PLANNING REPORT

MINOR CHANGE

**(A006290447: Development Permit for
Material Change of Use - Multiple Dwelling)**

**34-42 Grantson Street, Windsor
Lots 1-3 on RP18464**

3.1.1 Pre 1911 Structure

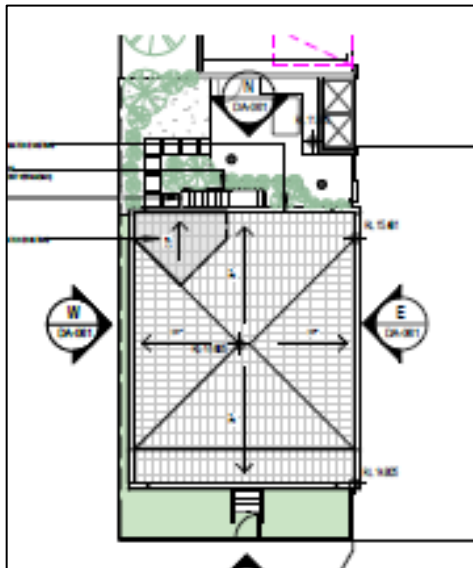
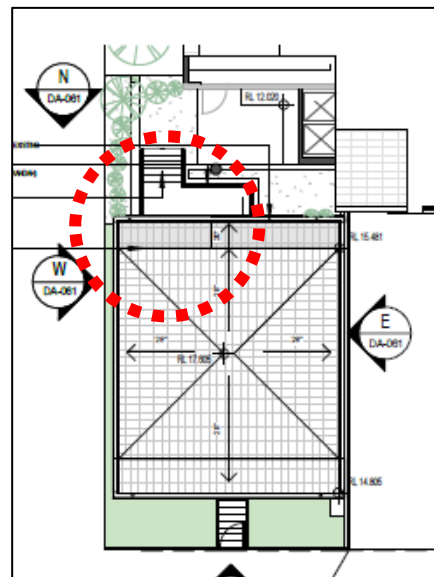
- Remove rear gable roof extension and retore to original roof form

3.1.2 Lower Basement:

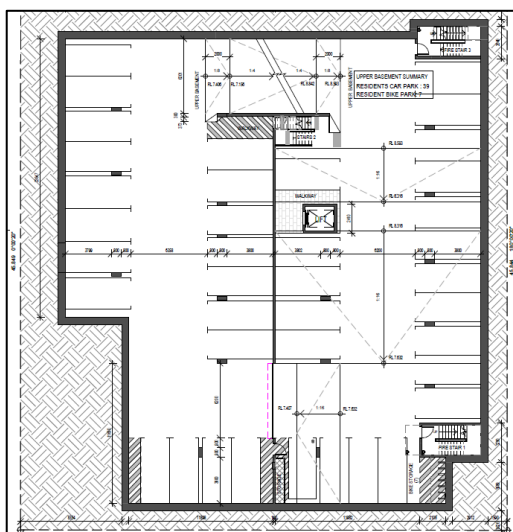
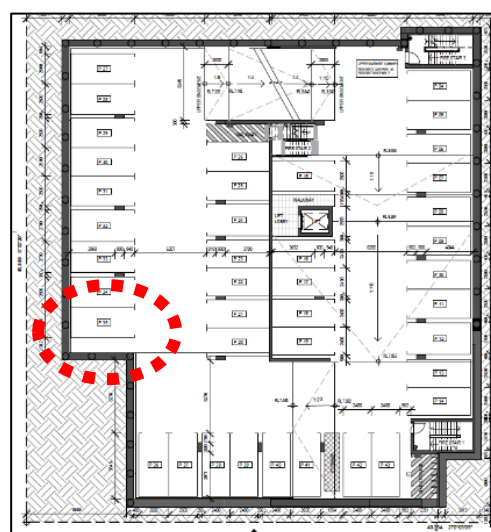
- Minor extension to basement and 1 car park added.

3.1.3 Ground Level Floor Plan

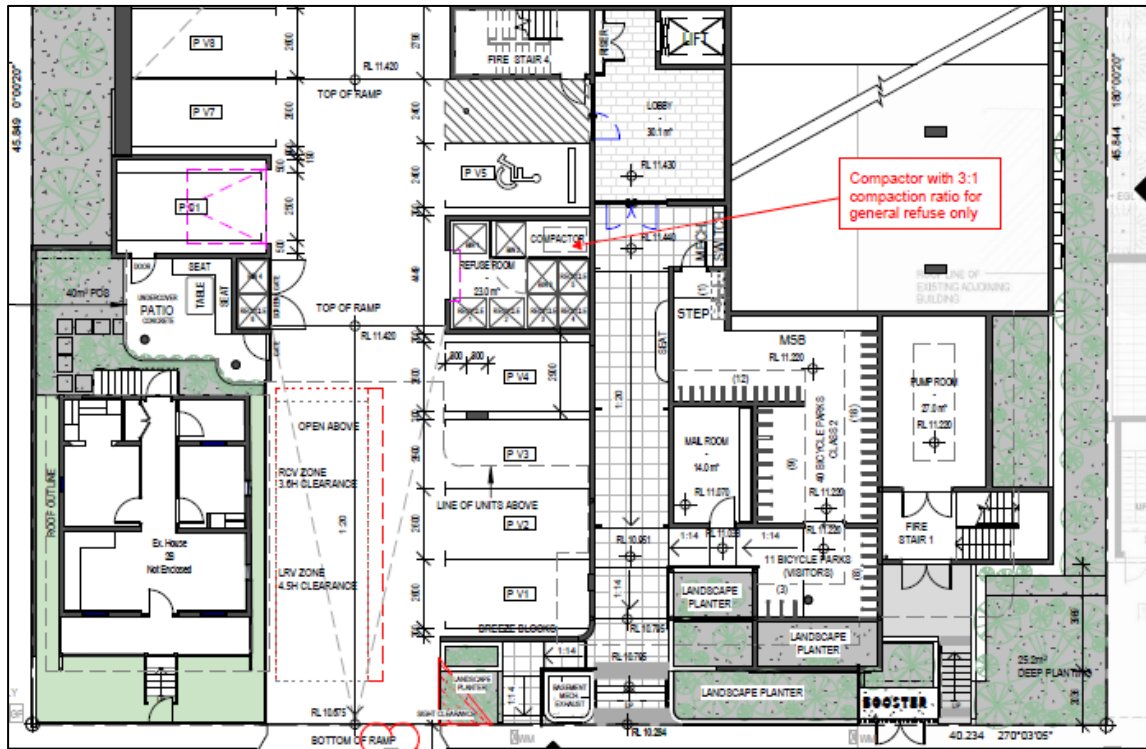
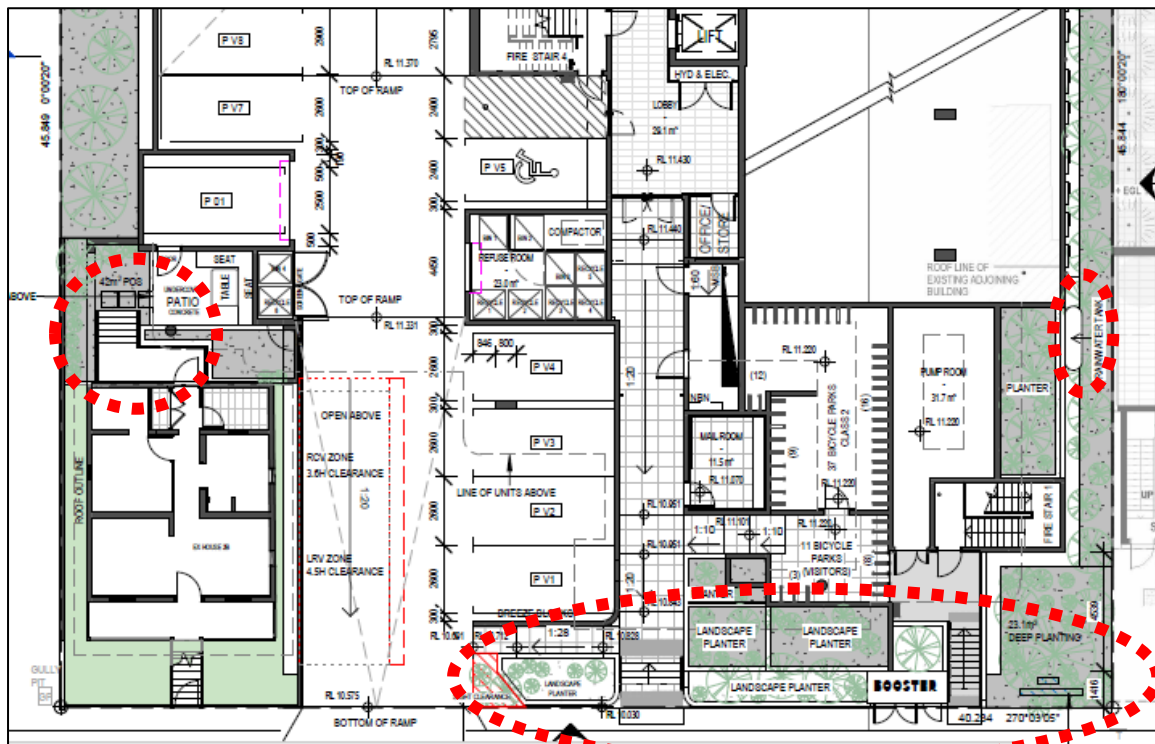
- Revised rear stair to “house” unit.
- Revised street entry & planters’ arrangements.
- Notate required water meter.
- Notate irrigation tank.

5.1.4 Roof Plan

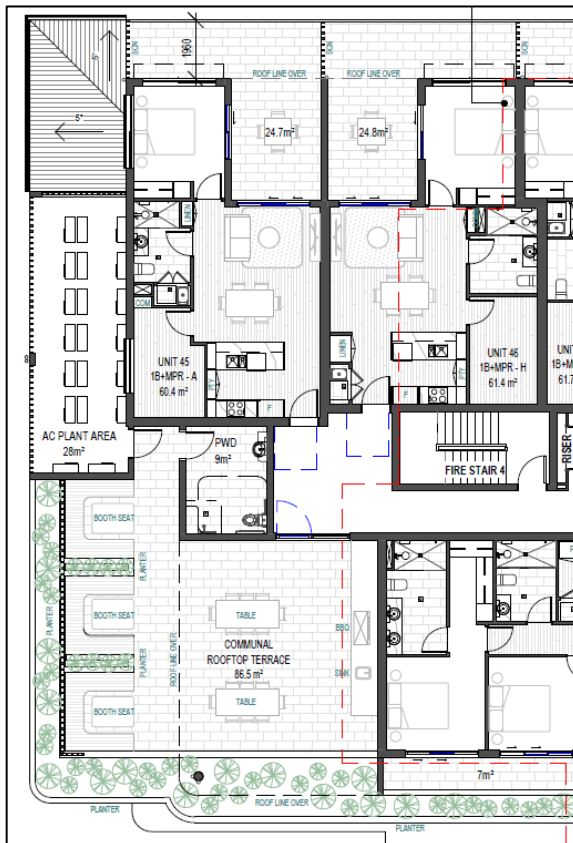
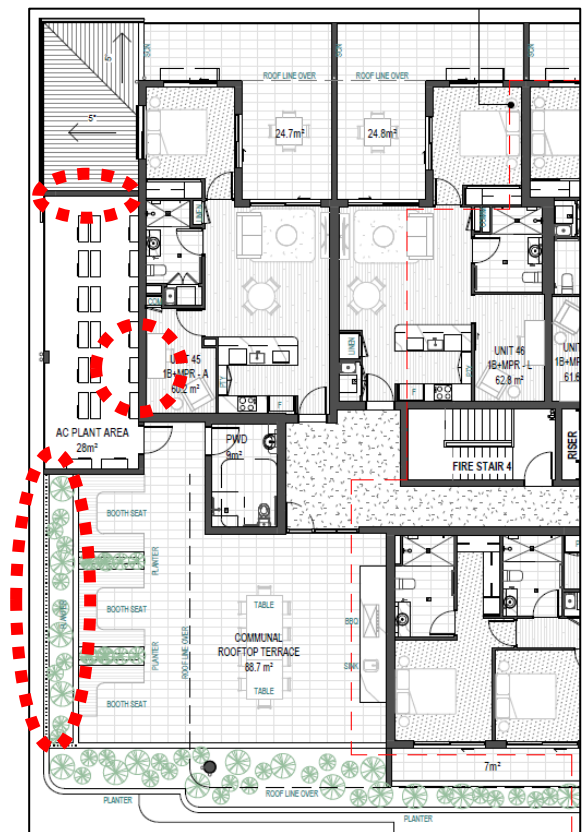
- Replace screen on the northern edge of the rooftop AC deck with a solid wall to reduce potential acoustic impact on the adjacent unit.
- Replace side window to unit 45 MPR to improve acoustic screening to unit.
- Relocated screen on the western edge of the rooftop communal planter.
